NextEra Energy Quality Assurance Topical Report (FPL-1) Revision 21 Annual Submittal

**NextEra Energy
QATR (FPL-1)
Change Summary**

NextEra Energy Quality Assurance Topical Report Change Summary
June 2017
(Page 1 of 4)

Chart 1 of 2: Corporate

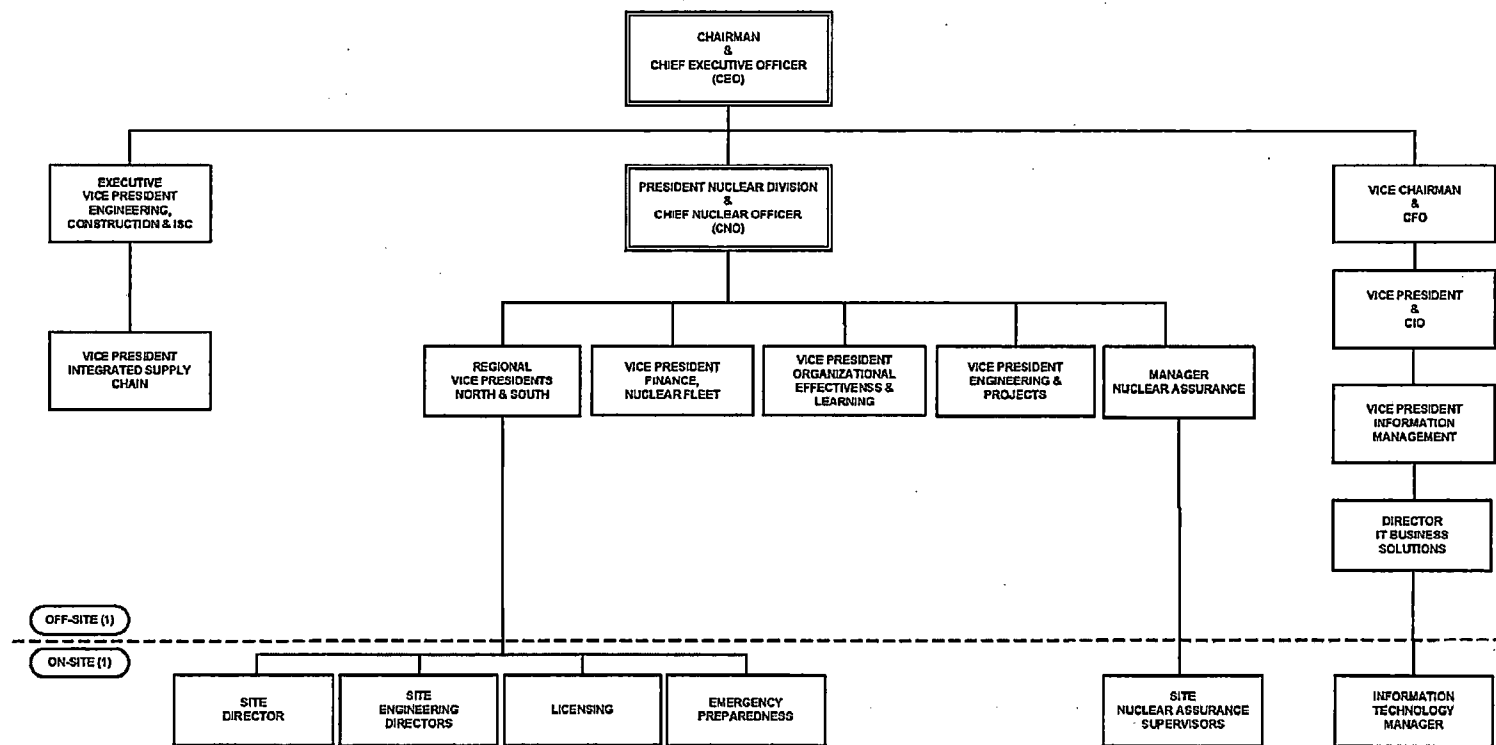
Change / Reason for Change (QR049: 2 of 3)	
Update Sections A.2, Organization and Appendix E, Organization Charts with Chief Nuclear Officer (CNO) Organization Announcement Dated August 11, 2016: (1) Fleet Support: Vice President for Organizational Effectiveness and Learning will have responsibility for Security, Training, Licensing, Corporate Functional Area Managers, Continuous Improvement Program, Nuclear Oversight and the new Performance Improvement and Assessment group, including Performance Improvement. This position will report directly to the Chief Nuclear Officer. (2) Project Controls: A new organization will be established for Project Controls that will report to the Vice President Project Controls & Strategic Alliances in an effort to make the organization more streamlined. The Project Controls team will realign under the Vice President Project Controls & Strategic Alliances. The Vice President Projects will continue to lead projects and report directly to the CNO. (3) Site Engineering Directors: Directors of Engineering at the sites will now report to the Site Vice Presidents. (4) Engineering Fleet: Vice President Nuclear Fleet Engineering Support will report directly to the CNO along with five direct reports who will lead Programs, Probabilistic Risk Assessment, Equipment Reliability, Fuels and Chiefs. The CNO and Vice President Nuclear Fleet Engineering Support will work together to redefine functional core business, roles and responsibilities. The Nuclear Engineering Director Fleet will oversee the Chiefs organization and report to the Vice President Nuclear Fleet Engineering Support. (5) Outage Managers: The Outage Managers will continue to report to the site but will now also be matrixed to the Vice President Fleet Outage. The fleet Outage organization and Vice President Fleet Outage will report to the Vice President Projects. The Vice President Projects and Vice President Fleet Outage will continue to refine the roles and responsibilities to outage performance. (6) Site Leadership: The Seabrook Site Vice President, as part of individual development, will lead Point Beach performance in addition to responsibilities serving as the Site Vice President, which will report directly to the CNO. The Point Beach Site Vice President, will report directly to the Seabrook Site Vice President and have a dotted line reporting relationship to the CNO.

Update Sections A.2, Organization and Appendix E, Organization Charts with Chief Nuclear Officer (CNO) Organization Announcement Dated January 3, 2017: (1) Regional Support: To provide increased oversight to the plants, Regional Vice Presidents have been appointed to the Southern Region (St. Lucie and Turkey Point) and Northern Region (Duane Arnold, Point Beach, and Seabrook). The Site Engineering directors will report directly to the Regional Vice Presidents, as will Emergency Preparedness and Licensing managers. (2) Site Leadership: As part of Accelerate, the roles of Site Vice President and Plant General Manager (PGM) will be merged into one streamlined role with the title of Site Director starting in 2017 with a targeted completion at all sites by mid-2018. These positions will report to the Regional Vice Presidents. The Site Director role will be responsible for Operations, Work Control, Maintenance, Radiation Protection, Chemistry, Outage, Performance Improvement, Safety and Training. (3) Fleet Support: The Vice President Projects will take over responsibility for Engineering in addition to the current role leading Projects, combining it into one organization, inclusive of governance and oversight of fleet outages. The Business Operations, Project Control and Accounting teams will report to the Chief Financial Officer. New Nuclear Projects (Turkey Point 6 & 7) will report directly to the CNO. (4) The Nuclear Assurance Manager will return to reporting to the CNO.

Appendix E: Organization Charts
Chart 2 of 2: Site

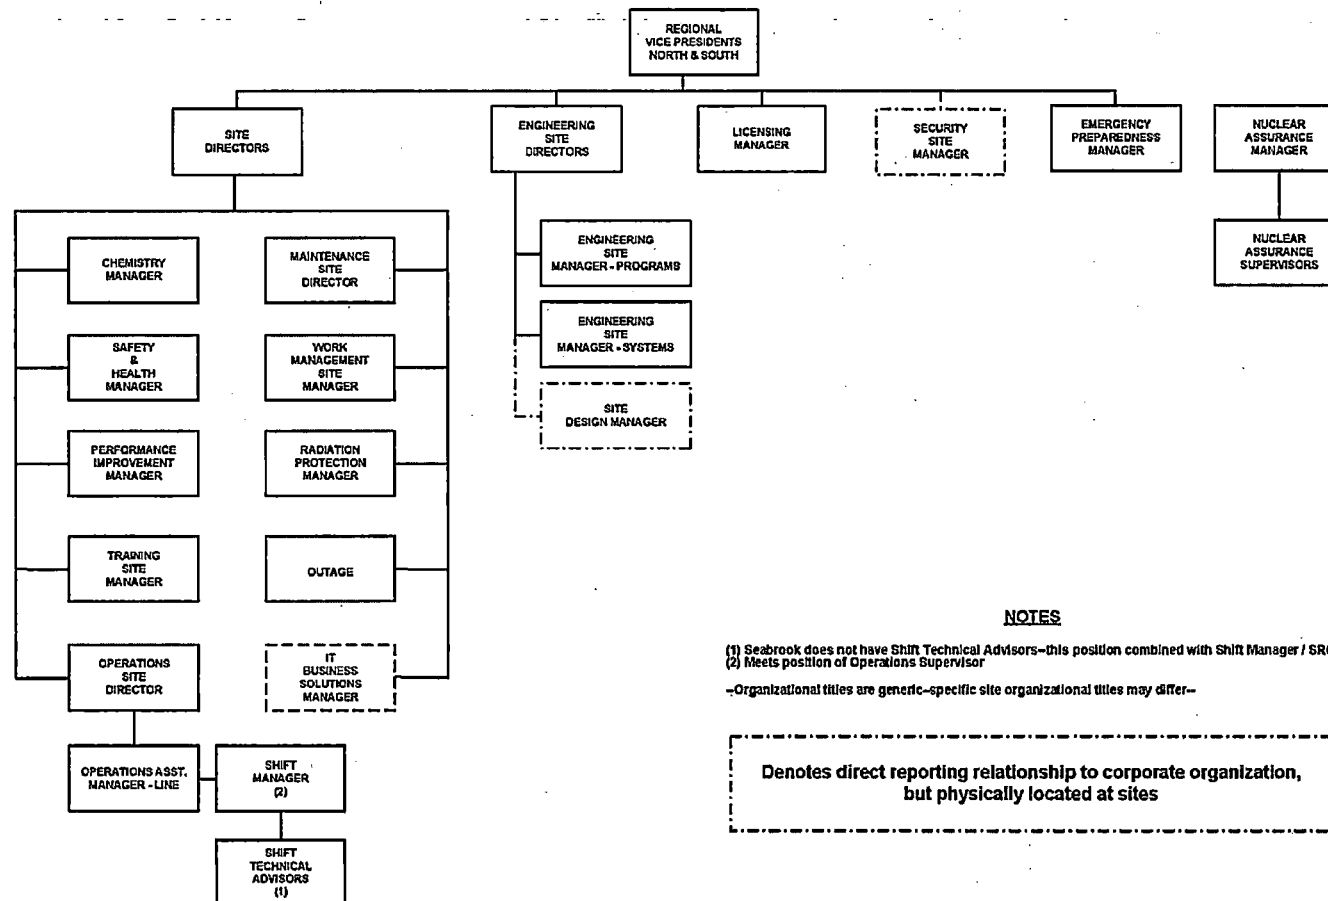
Change / Reason for Change (QR050: 4 of 4)	
Appendix E, Site Organization Chart: Show IT Business Solutions Manager in a dotted box, which reports to a Corporate position.	
Basis for Concluding that the Revised Program Continues to Satisfy 10 CFR 50 Appendix B & Commitments Previously Accepted by the NRC This change is to correct an administrative error made during development of QATR Revision 20 describing the reporting responsibilities between the IT Business Solutions Manager and the Site Director. The change is an Administrative change as described by 10 CFR 50.54 (vii) and is not considered a reduction in commitment.
